W31: IH-10 Boerne Stage to Old Fredericksburg Sanitary Sewer

Job No.: 09-2502

ADDENDUM 2

October 4, 2016

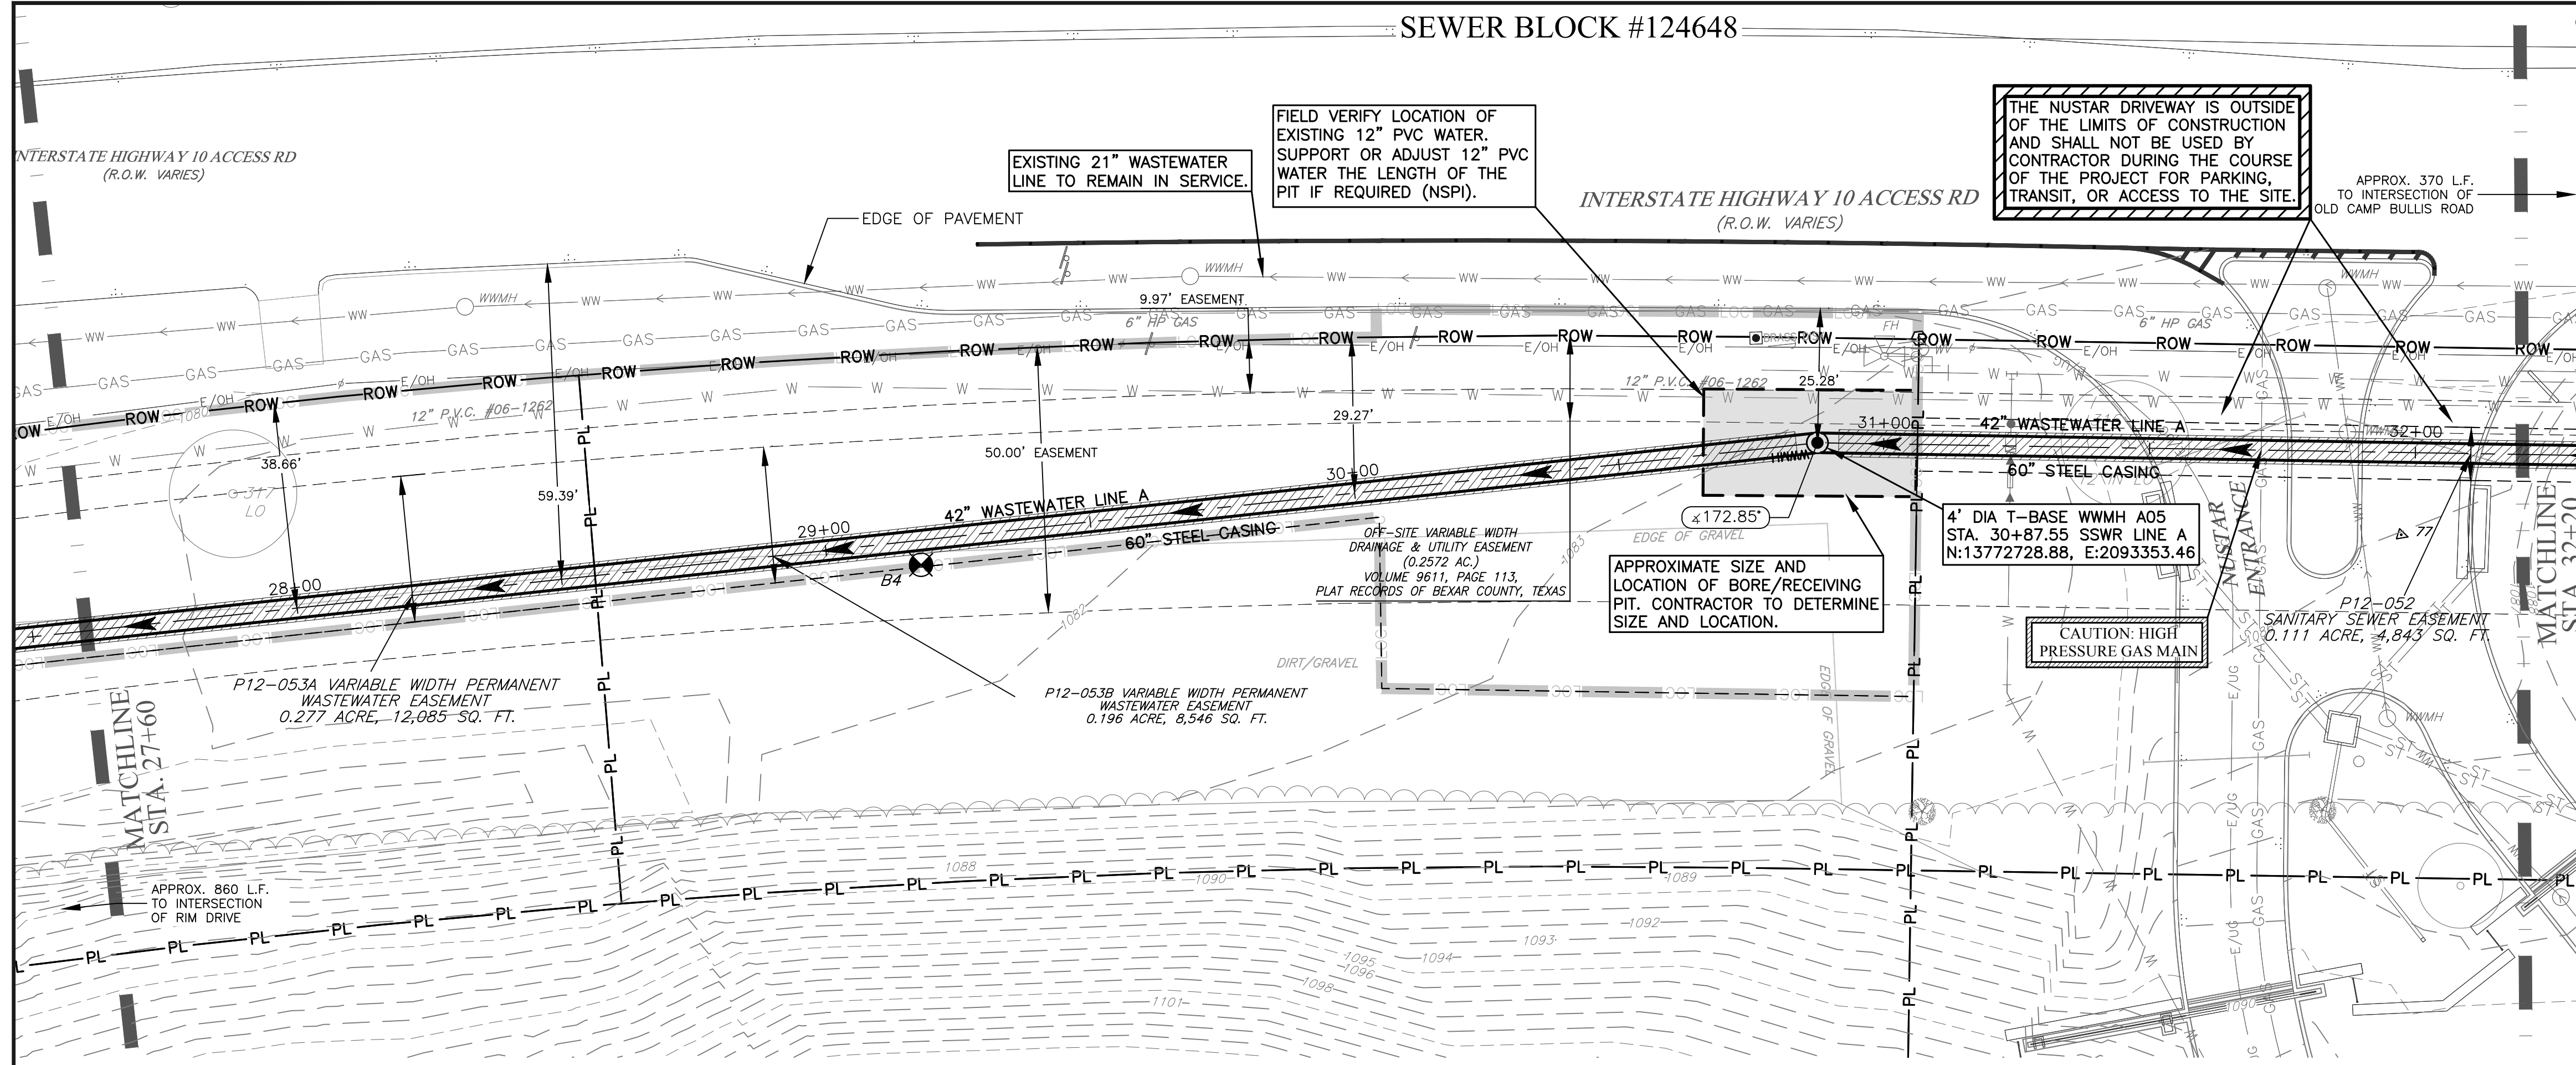
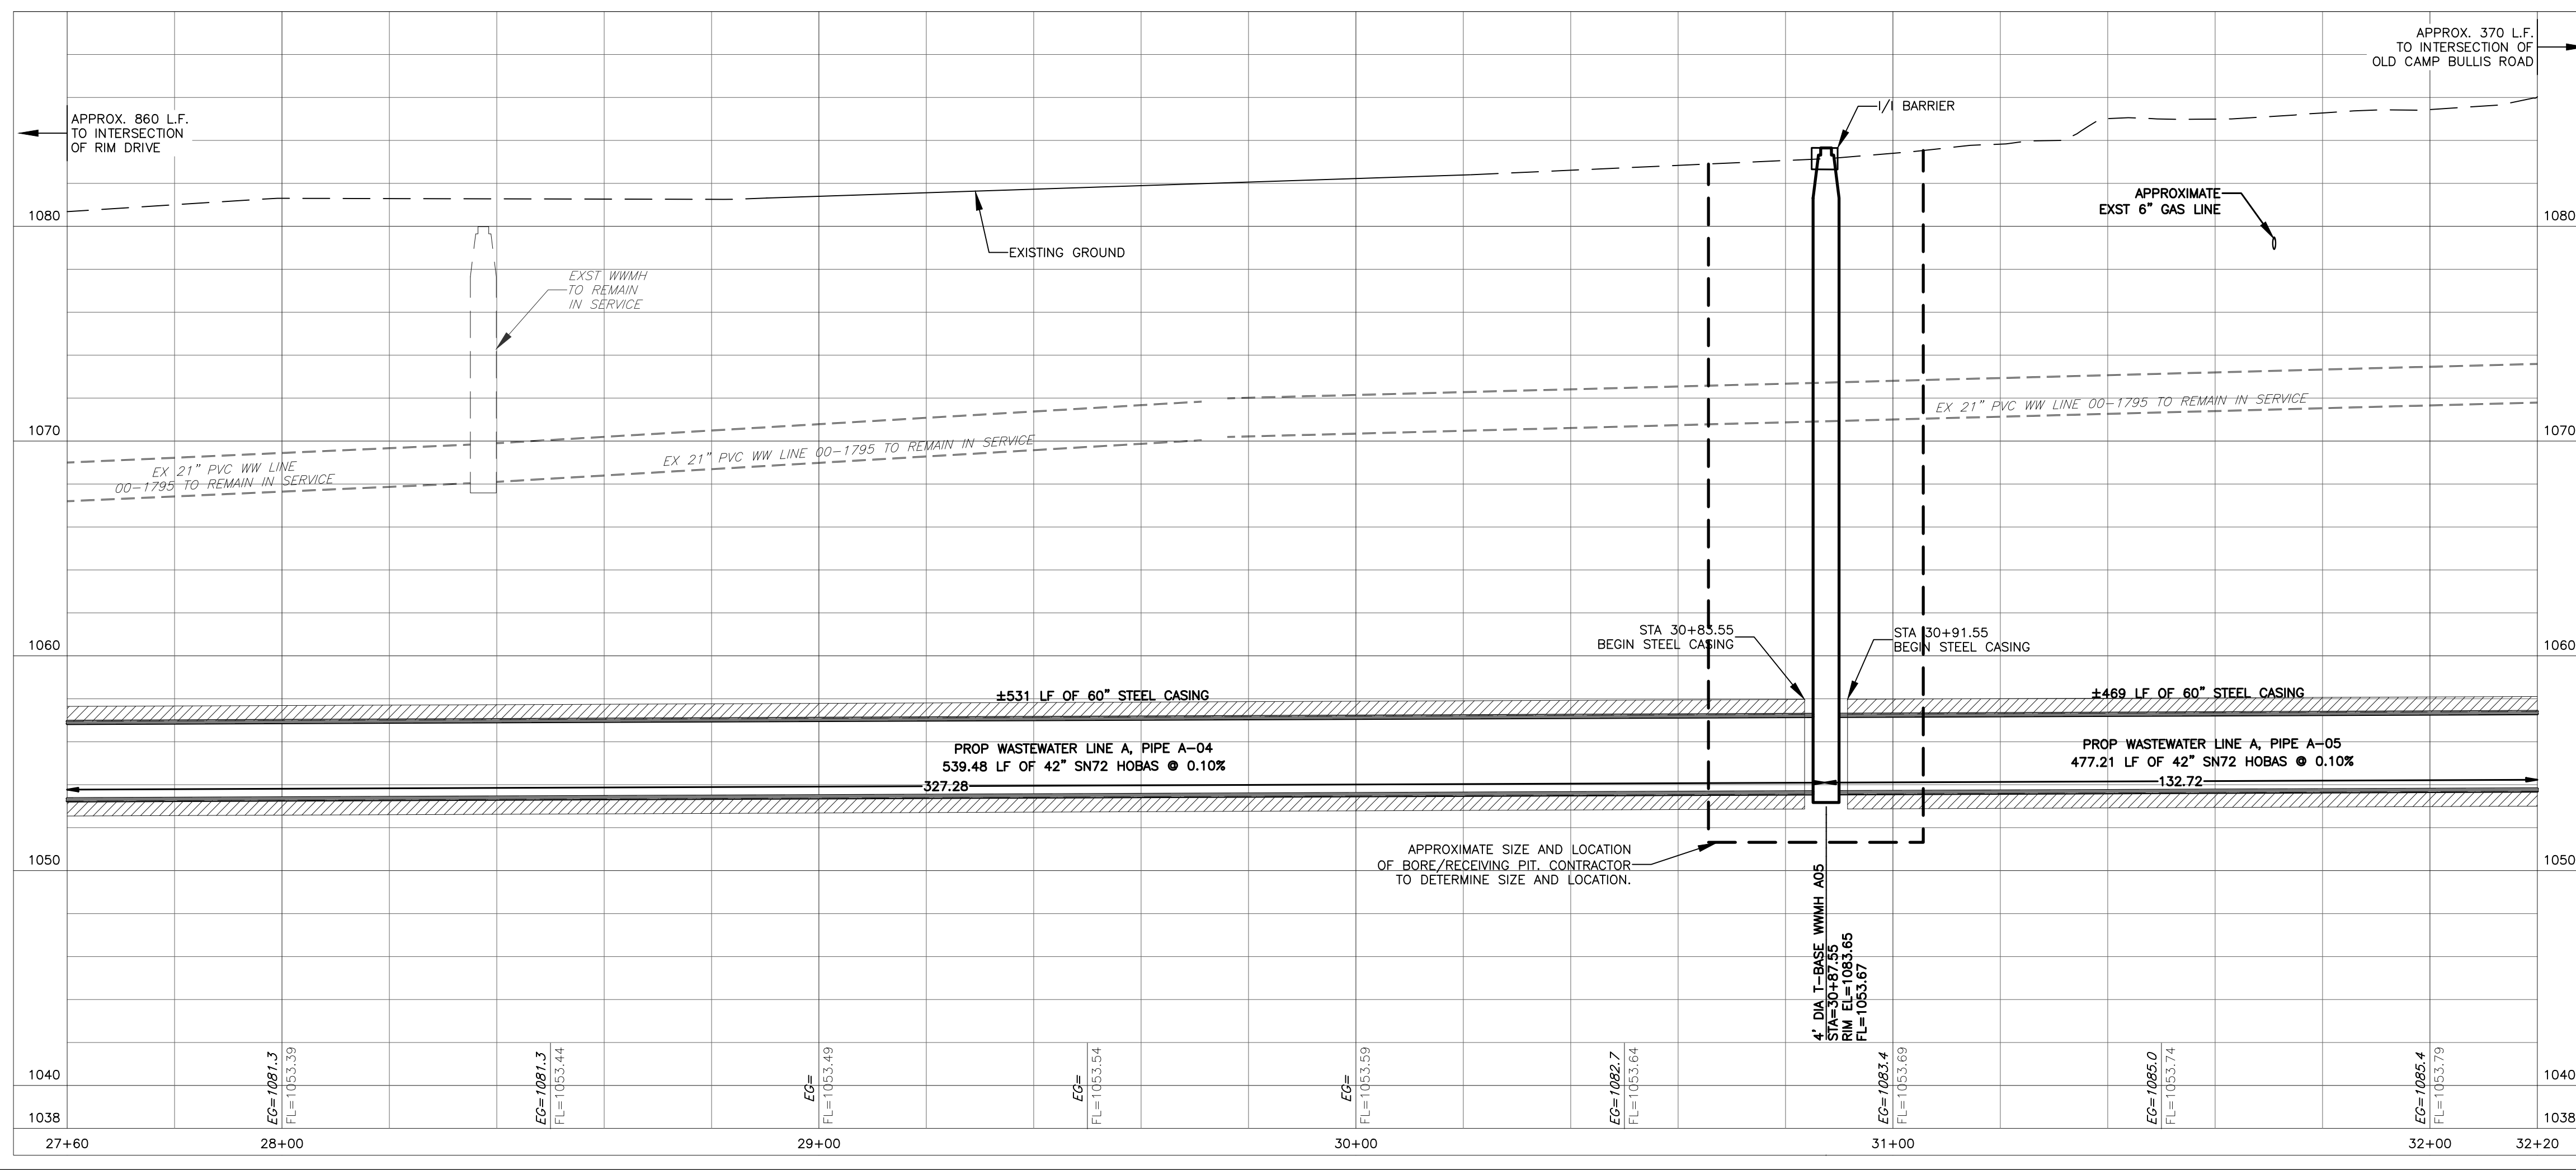
3. The following note was added to Sheets C-9, C-10, C-12, C-13, C-14, C-15, C-45, and C-46:

"The Contractor shall provide the property owner a written notice of initial entry 10 days prior to start construction within their property."

SPECIAL NOTE:
 1. THE CONTRACTOR SHALL PROVIDE THE PROPERTY OWNER A WRITTEN NOTICE OF INITIAL ENTRY 10 DAYS PRIOR TO START CONSTRUCTION WITHIN THEIR PROPERTY.
